35/54-94B 8817 Hawkins Lane
Hawkins Lane Historic District

HISTORIC PRESERVATION COMMISSION STAFF REPORT

Address: 8817 Hawkins Lane	Meeting Date: 06/08/94
Resource: Hawkins Lane Historic Dist.	HAWP: New Construction
Case Number: 35/54-94A ^B REVISION	Tax Credit: No
Public Notice: 05/25/94	Report Date: 06/01/94
Applicant: Ronald Hsu & Walter Hsu	Staff: Patricia Parker
PROPOSAL: New construction/Single-family home	RECOMMEND: Approval

HISTORIC PRESERVATION COMMISSION STAFF REPORT

FRONT ELEVATION

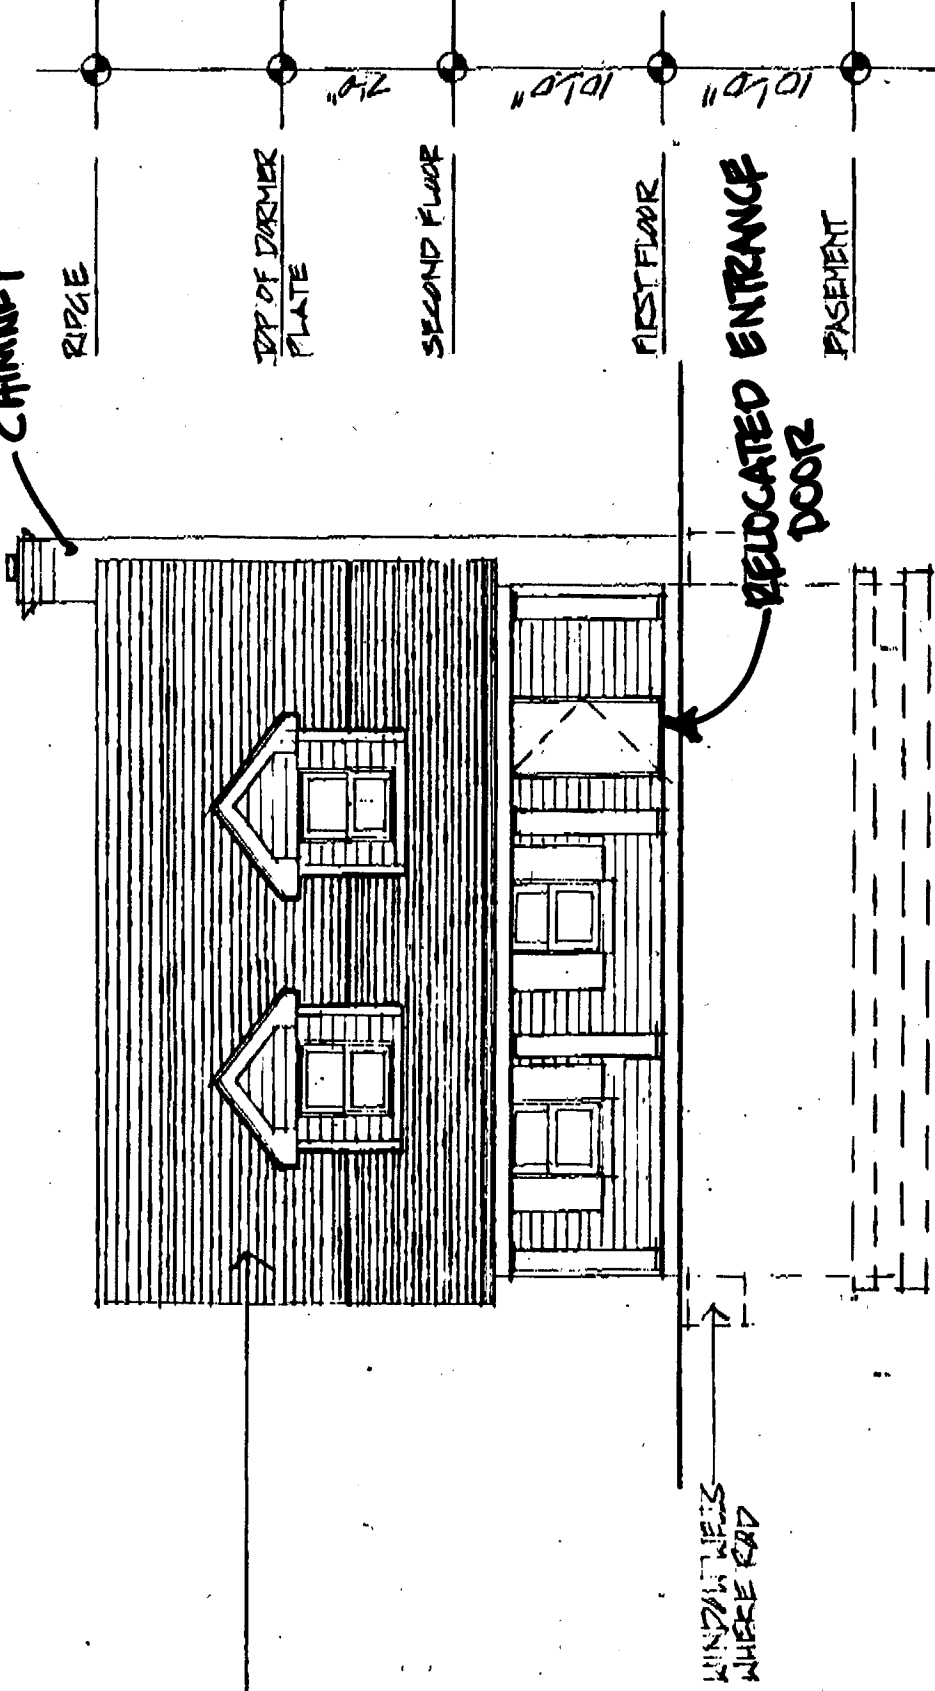
The applicant now proposes, in addition to his acceptance of the conditions placed on the approved HAWP, to 1) construct a brick chimney on the side elevation (south elevation) and 2) to move the front entrance door off center by approximately 5 feet. This door relocation is necessary to rationalize the interior floor plan.

- The project is to move the front door
5 feet to the right.
- A ϕ back fire place.

SIDE ELEVATION

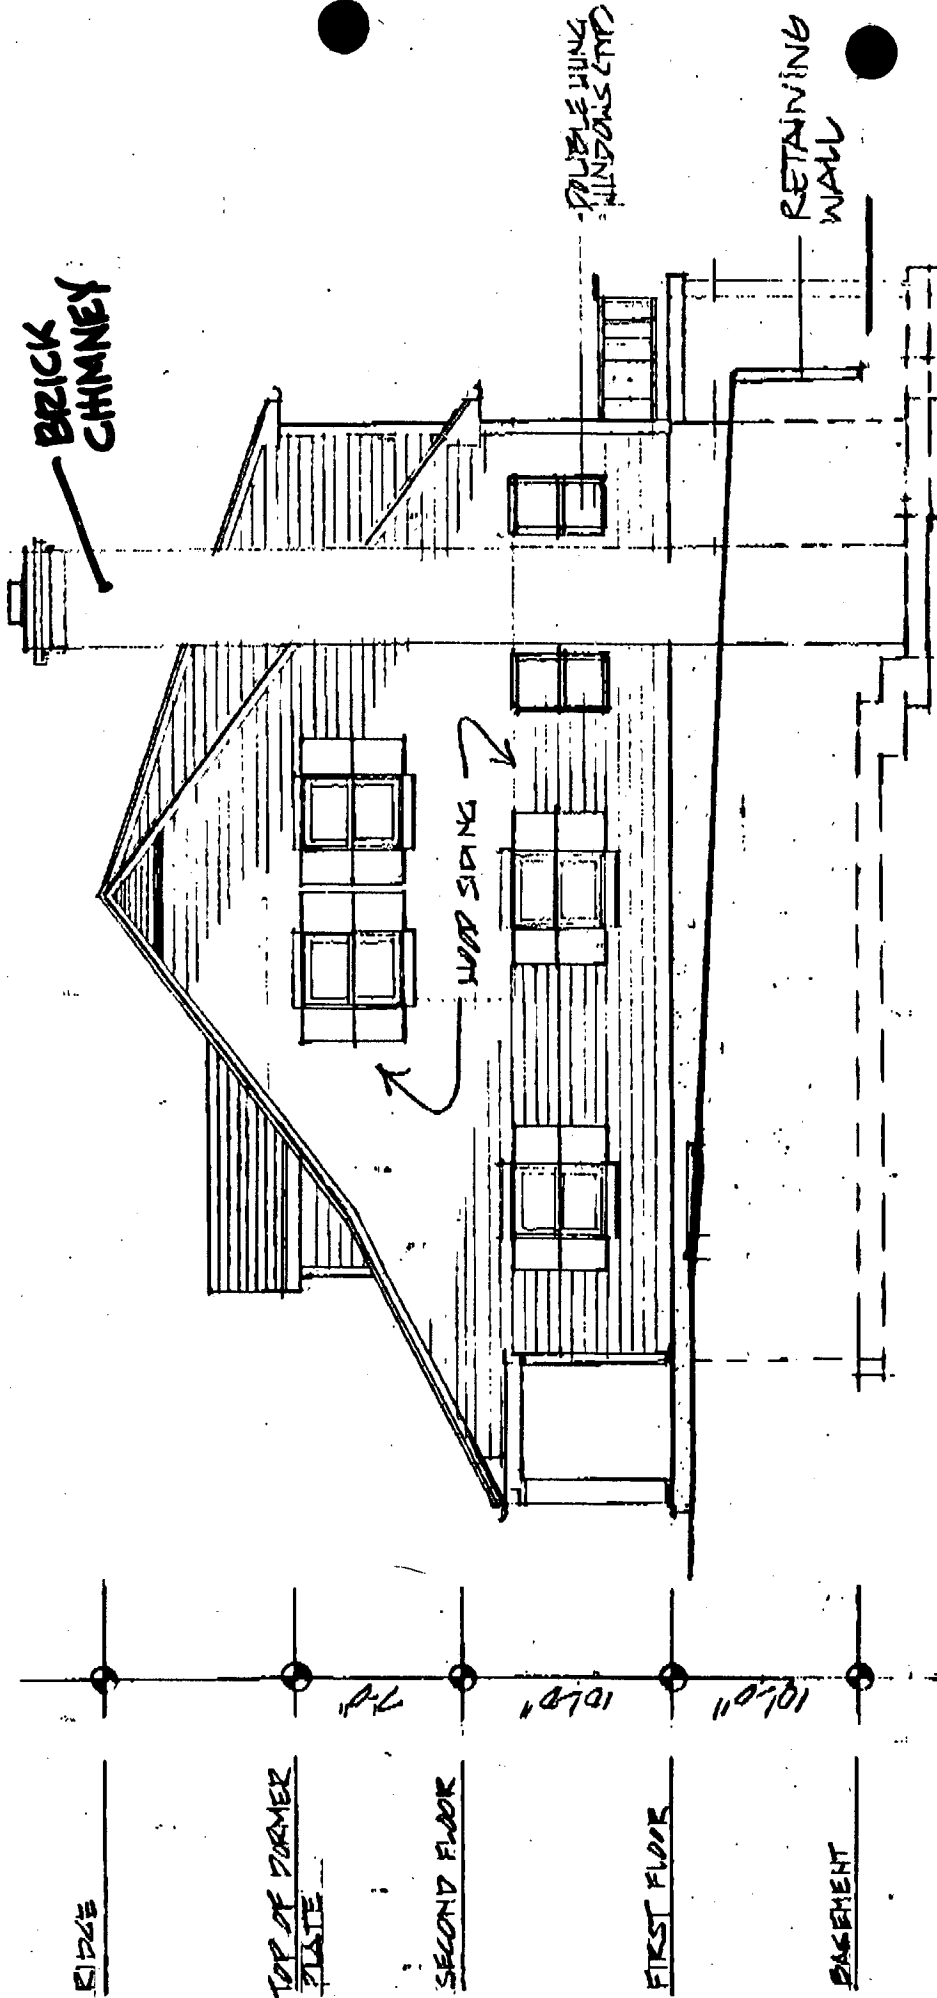
- Brick fireplace.

REAR ELEVATION
SCALE: 1/8" = 1'-0"

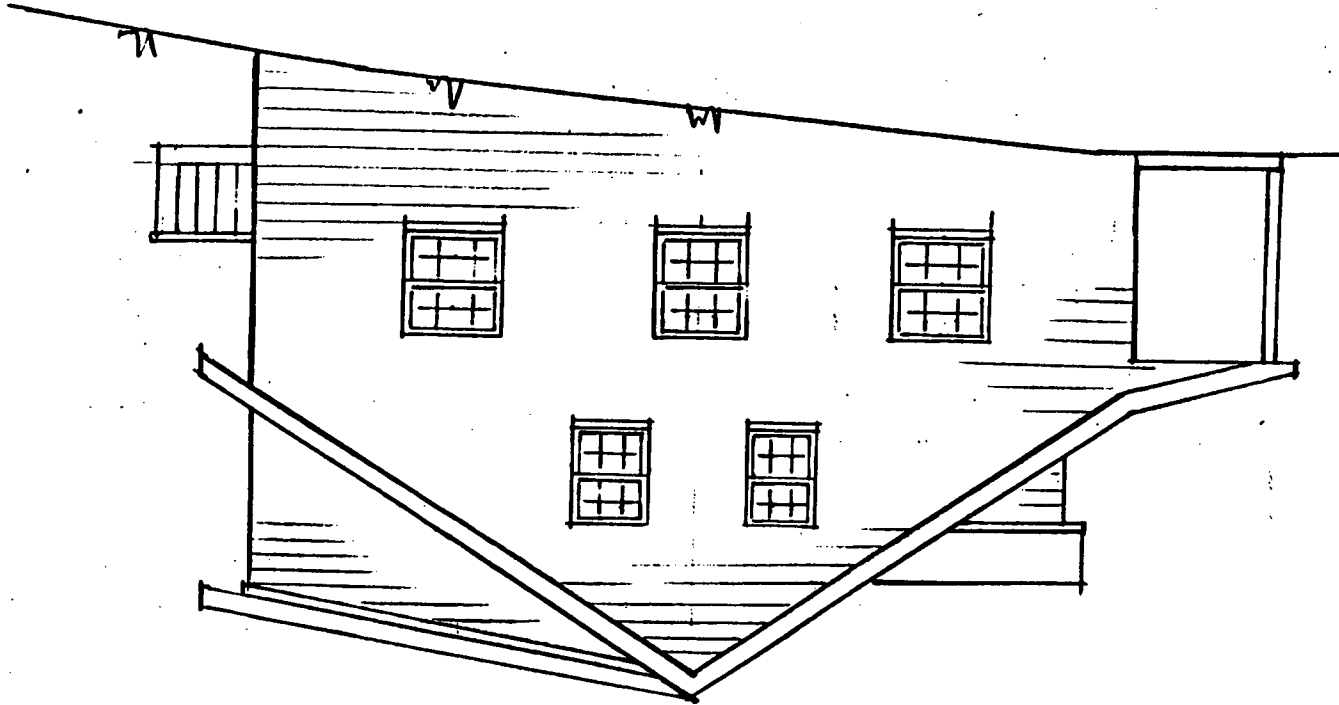
o The rear elevation shows four openings of questionable size. Staff was not provided with floor plans; but would not find one sliding glass door opening on the first floor level to access the deck, plus one sliding glass door on the basement level to access the back yard problematic. However, the other openings on this elevation - on the first and basement floors, and on the second floor if a rear dormer is permitted - should be consistent in size and configuration with those on the other elevations.

The openings on the first and basement floors of the rear elevation are shown elongated. Staff suggests that one sliding glass door be permitted on the first and basement floors of the rear elevation. The remaining windows should conform with those

1. The rear dormer should be deleted from the proposal.
2. During construction, the applicant must provide for and assure the continued good maintenance of roadway surfacing for Hawkins Lane.
3. Window openings shall be consistent in size and configuration on each of the building's elevations - with approval of one sliding glass door on the first floor of the rear elevation and on the basement floor of the rear elevation. Windows shall be wood double-hung 1/1, trimmed with shutters 1/2 the width of the opening for each panel.
4. All trim shall be of wood, including cornice and cornerboards.
5. The porch posts shall be wood - simple, devoid of ornamentation - 6" X 6" or 8" X 8" in size.
6. New driveway surfacing shall be gravel.

PLAN VIEW

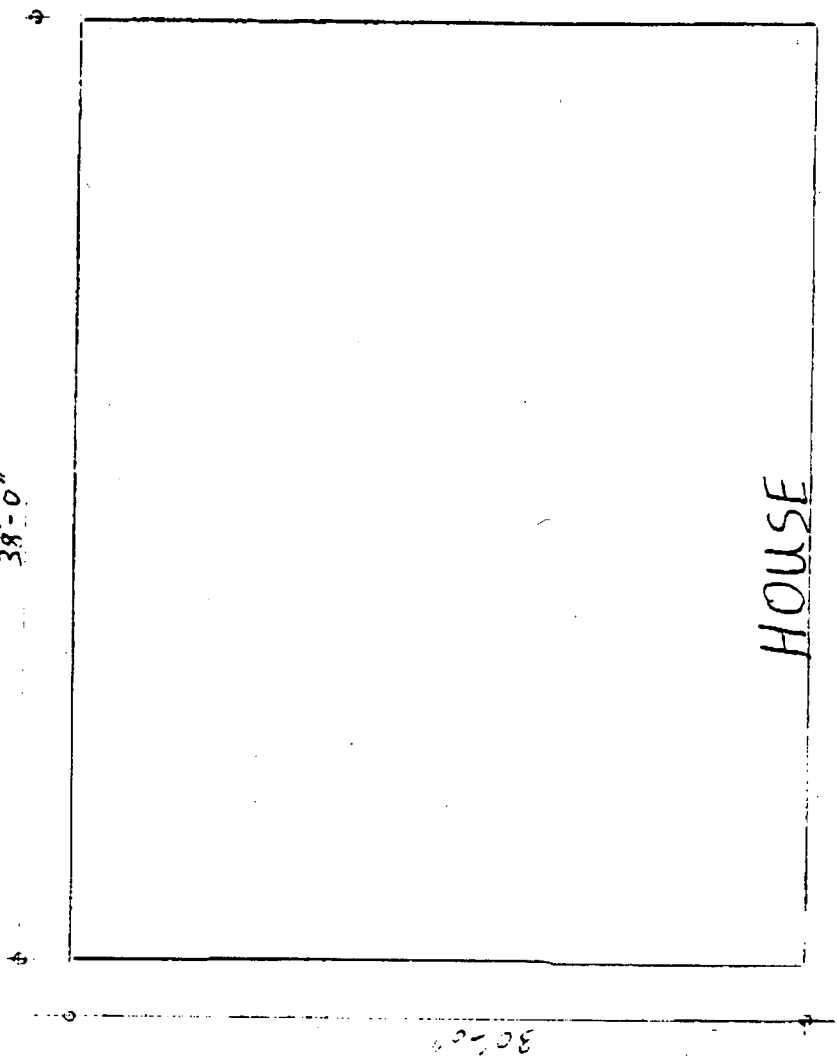
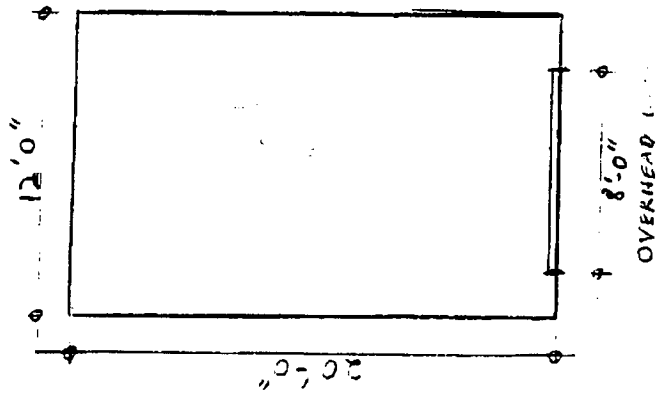
o Plans for the garage are now included. The garage would be 12' by 20' and serviced by a driveway straight off Hawkins Lane. The exterior would be painted wood siding. Staff strongly recommends that the surfacing of the driveway be gravel. The driveway is adequately separated from adjacent property.
